TECHNICAL EVALUATION REPORT

EVALUATION OF THE DOE STANDARD MHTGR  
CONTAINMENT DESIGN ALTERNATIVES

Project: Safety Review of High Temperature Gas Reactors (HTGRs) (FIN No. A9477, Task 2.1).

Fig. 3.1. Isometric view through reactor building (Maneke, 1988)

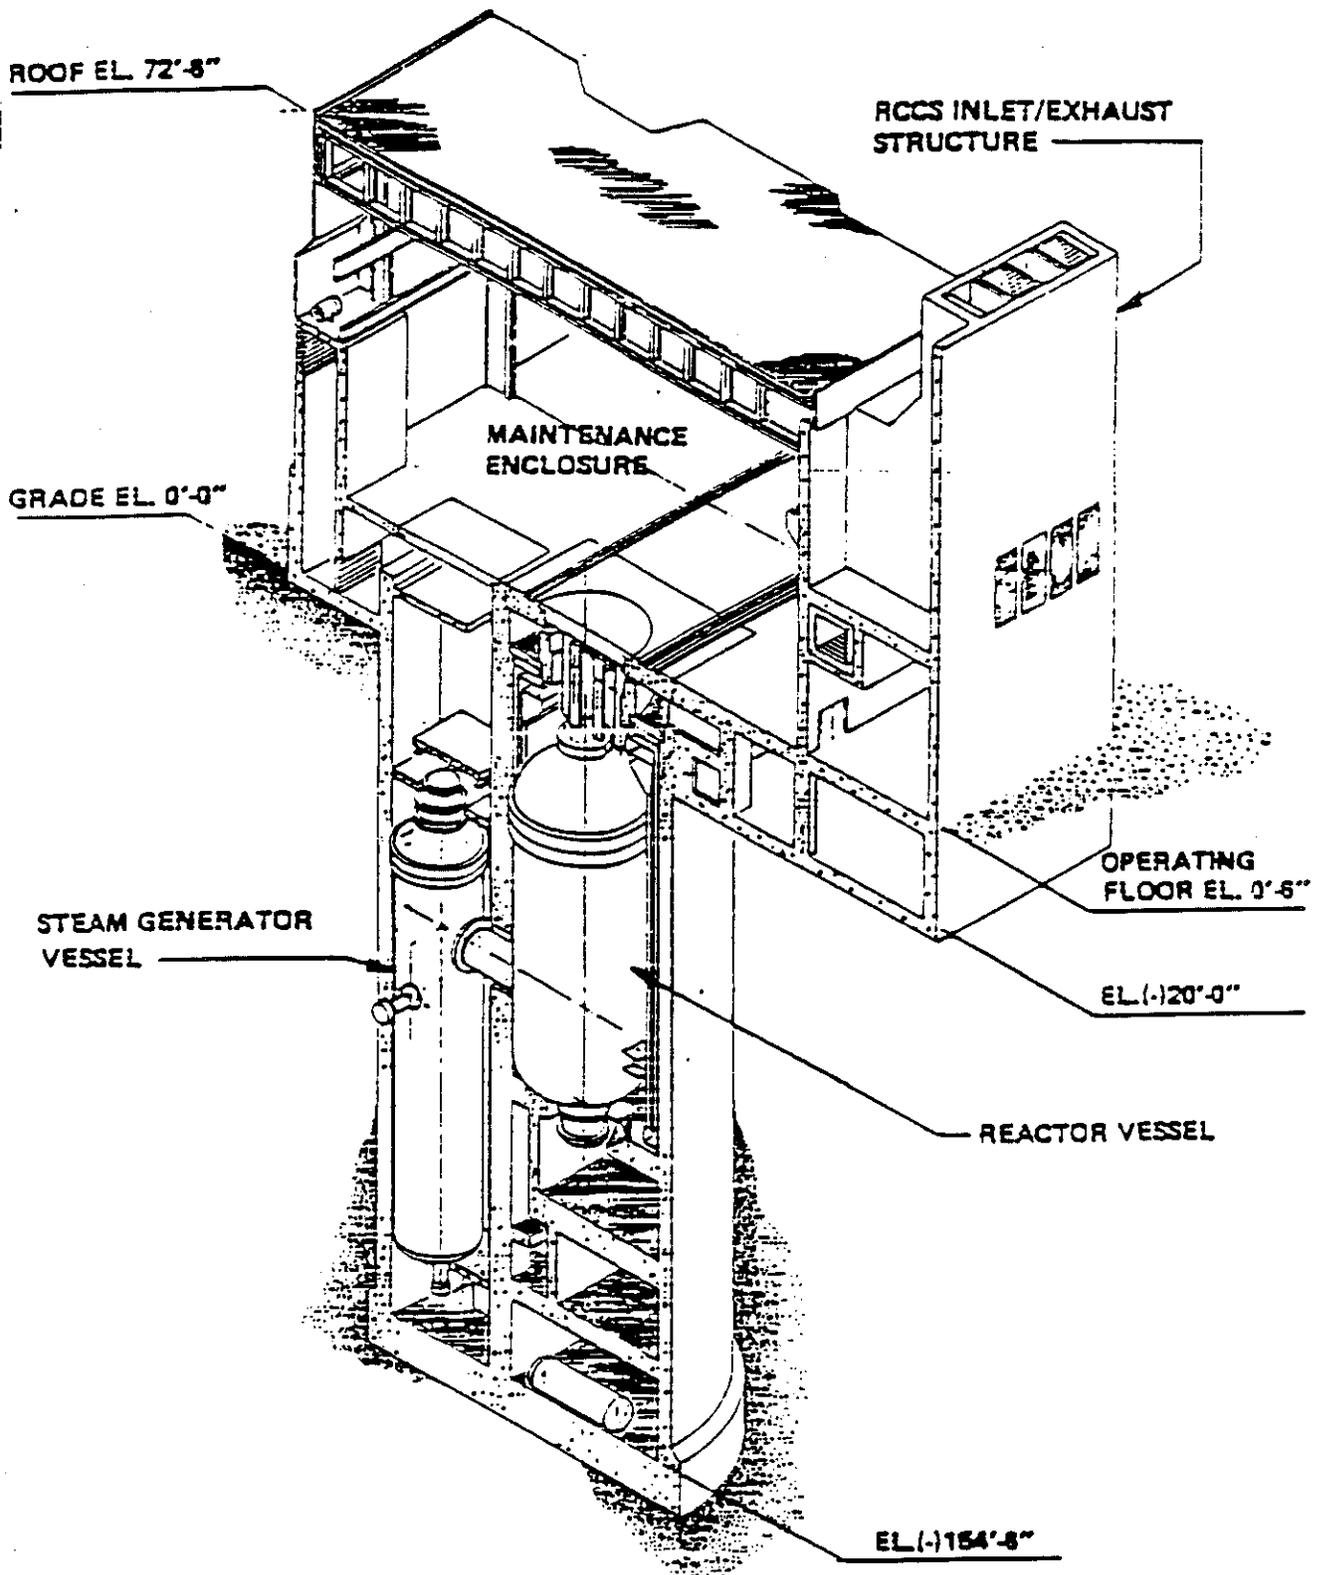
Maneke (1988) provides a fairly good description of the base case reactor building, including description of the internal rooms and flow paths for releases from the primary containment to the atmosphere. Figures 3.1 and 3.2, from Maneke, show an isometric of the building and the leakage paths through the building, respectively. Note that a leak from the reactor vessel flows downward, past the cool RCCS surfaces and into a series of chambers underneath the vessel. A blowout panel allows flow to proceed upward into the steam generator cavity, and from there through baffles into a circular plenum, the ceiling of which is at ground level. The path in the plenum leads first through hinged louvers, then upward through fixed louvers, from which the flow is discharge to the atmosphere at elevation +30 feet.

Discharge to the atmosphere can be separated into two time periods. Initially, the discharge is impelled by helium pressure from a failure in the pressure vessel boundary or by steam pressure from a failure in the steam generator pressure boundary. When pressures equilibrate, a leakage rate from the building of 100%/day is assumed. Though not stated, presumably this means that the volumes involved in the leakage pathway described above are combined, and one complete exchange occurs with outside air per day. However, the precise meaning of the assumed 100%/day leakage rate as well as its basis need to be stated. The principal mechanism affecting this exchange is probably natural convection.

Fig. 3.2. Vent pathway schematic (Maneke, 1988)

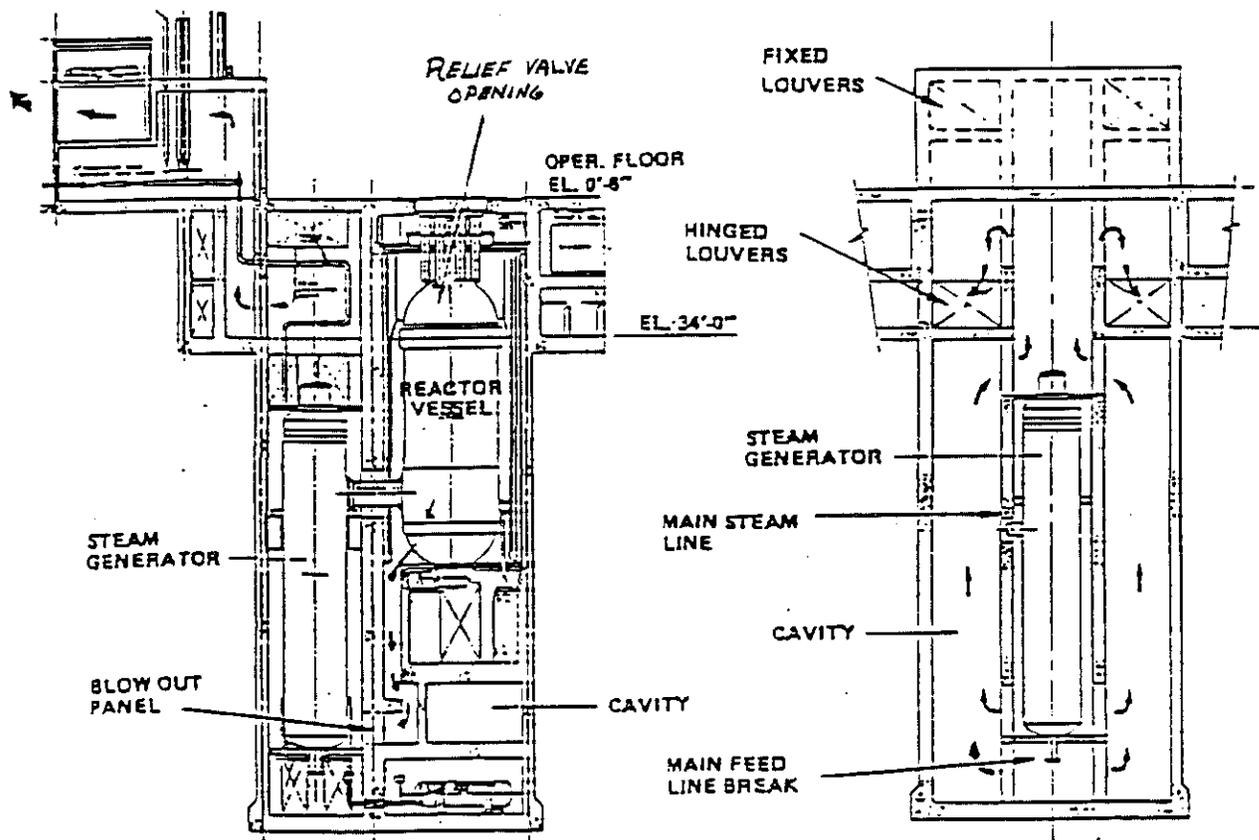
The radioactivity attenuation mechanisms that are effective in this flow path depend on the chemical form of the fission products entering the building:

Fig. 3.4. Flow characteristics of a single SGTS train

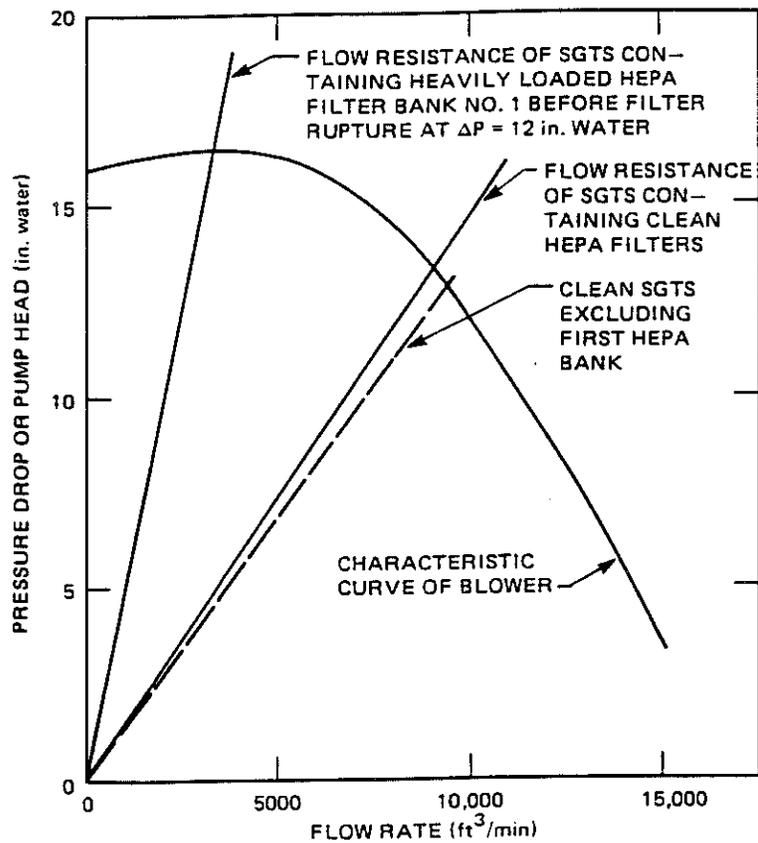
- a. A significant pressure drop is required to drive a large gas flow through the assembly. This is provided by a fan for the BWR application. Figure 3.4 (from Wichner, et.al., 1983) shows a typical fan head curve and assembly pressure drop. It is not clear what the effective flow through the filter would be for a pressure-equilibrated case with essentially no pressure driving force.
